From: Chun Yi Wu [chun.yi.wu@state.mn.us]
Sent: 8/7/2017 4:48:36 PM
To: Cheryl Emery [cbemery@mmm.com]
Subject: RE: 2014 ATEI - 2701500039

It was very nice to talk with you. I will use the following to summarize our effort on the review of 2014 emissions for ethylene oxide from the 3M - New Ulm - Electrical Products Division:

Figure 9. Ethylene Oxide Vertical Vent Line Installation (Example).

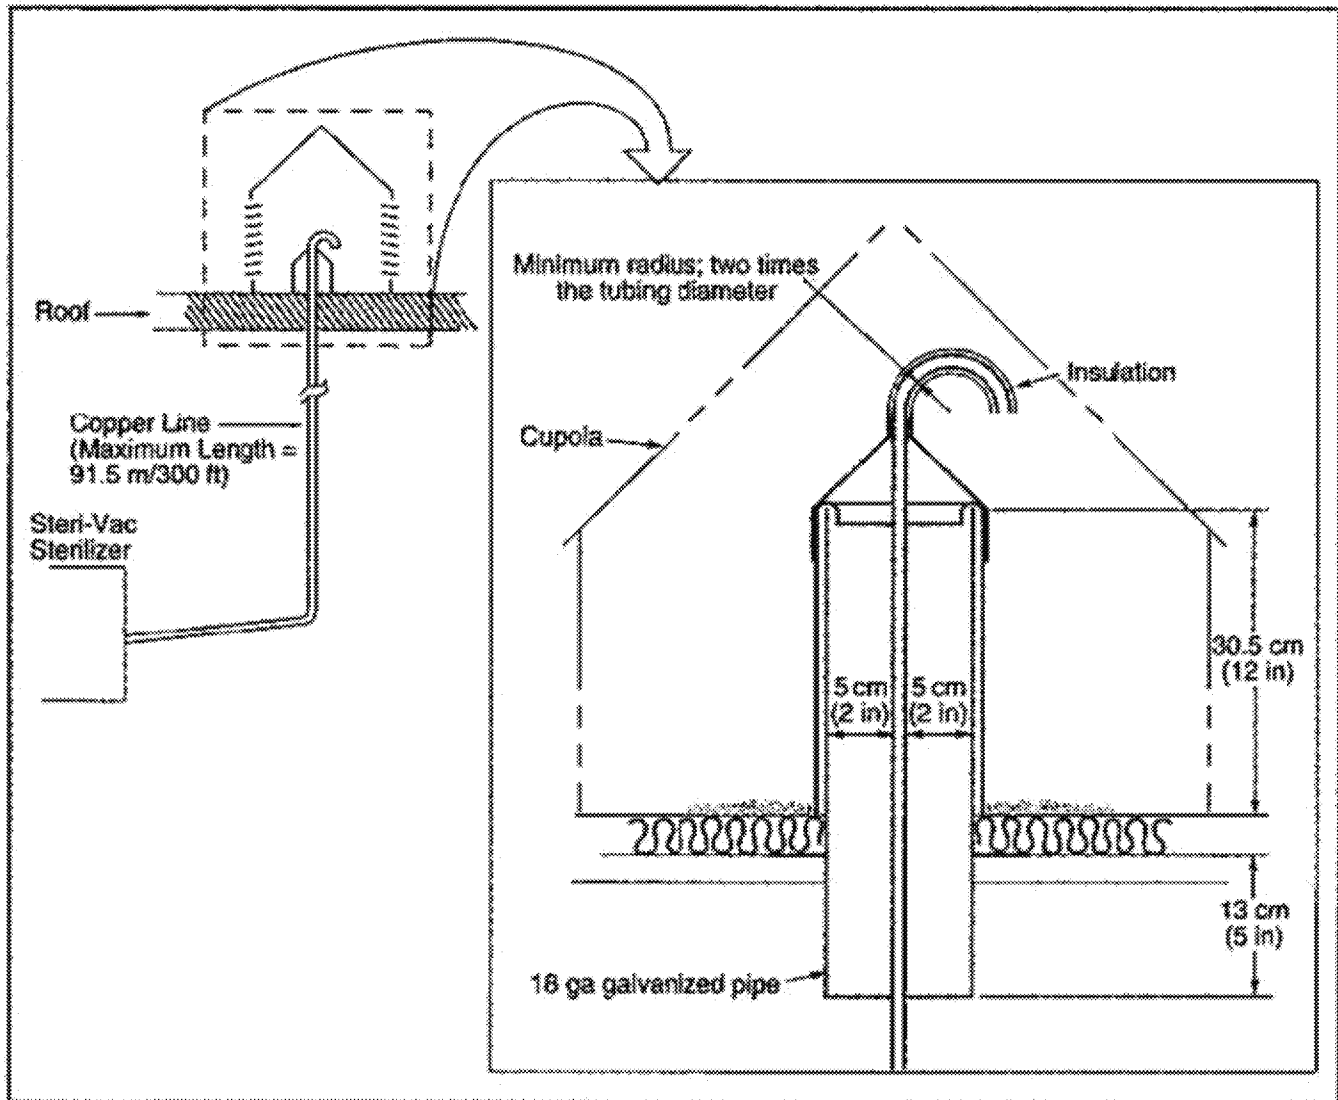
Are all these 4 each ¾" copper lines in the image you e-mailed to me?

Thanks for the detailed information to illustrate the ventilation. I see the insulation outside of the copper lines. What is the exhaust temperature? What is the air flowrate for each line?

I am sorry for the confusion. I added in the exhaust #5 which is the EtO cabinet that we store the small canisters of EtO which we also exhaust.

During testing, they hook up the ¾" cooper line to the exhaust. Each one of them exhaust to the roof.

The EtO cabinet that is also exhausted (Exhaust fan #5), has a 3" vent that goes into a different stack (#8). Theoretically, there should not be any EtO in the cabinet but we exhaust as a precaution.

What is the exhaust temperature? 55 degrees C

There are 4 each ¾" copper lines running through the roof of the building

The picture shows the vent stack on the roof which is ~10 foot high.
